Access Compliance Report

Public Rights-of-Way

(Curb Ramps)

Intersection ID: 21478	Main Street: KILCULLEN_DR	Cross Street: N/A	Location: NW
ADA ID: 6FE5C492D1A5	Ramp Type: PerpDiag	Initial Pass/Fail: Fail	Overall Compliance: No
		Severity Score: 25

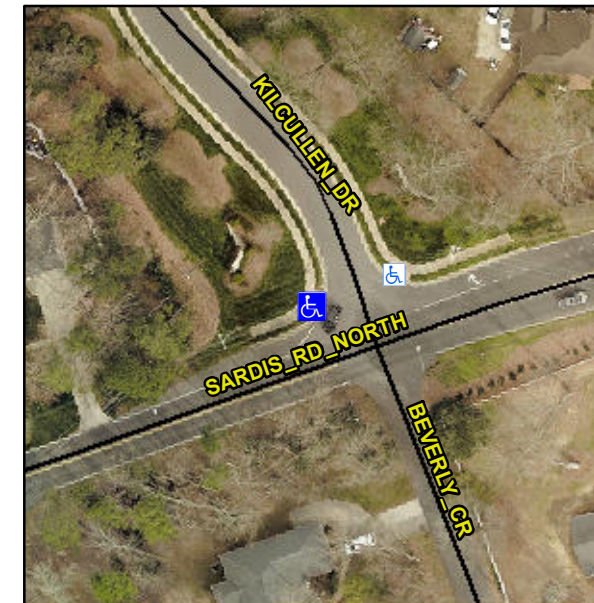
Not Found, R304.5.3

Compliance	Description	Data	Compliance	Description	Data
N/A	Ramp Length (in)	48.0	Yes	Ramp Slope (%)	7.4
Yes	Ramp Width (in)	48.0	No	Ramp XSlope (%)	8.0
N/A	Flare Type LT	N/A	N/A	Flare Type RT	N/A
N/A	Flare Slope LT (%)	N/A	N/A	Flare Slope RT (%)	N/A
N/A	Flare Traversable LT?	N/A	N/A	Flare Traversable RT?	N/A
N/A	Landing Length (in)	N/A	N/A	DWS Provided?	N/A
N/A	Landing Width (in)	N/A	N/A	DWS Contrast?	N/A
N/A	Landing Slope (%)	N/A	N/A	DWS Length (in)	N/A
N/A	Landing X Slope (%)	N/A	N/A	DWS Full Width?	N/A
N/A	Landing Curb? (Y/N)	N/A	N/A	DWS Offset (in)	N/A
N/A	Shared Landing?	N/A			
N/A	Gutter Ponding?	N/A	N/A	Gutter Slope (%)	N/A
N/A	Gutter Lip Ht (in)	N/A	N/A	Gutter X Slope (%)	N/A
N/A	Painted X Walk1?	No	N/A	Painted X Walk2?	No
	X Walk 1 Direction	To S		X Walk 2 Direction	To E
N/A	X Walk 1 Width (in)	N/A	N/A	X Walk 2 Width (in)	N/A
	X Walk 1 Slope (%)	1.4		X Walk 2 Slope (%)	5.8
	X Walk 1 X Slope (%)	5.2		X Walk 2 X Slope (%)	1.0

Remove & Replace Curb Ramp With Two New Directional Ramps or Equivalent.
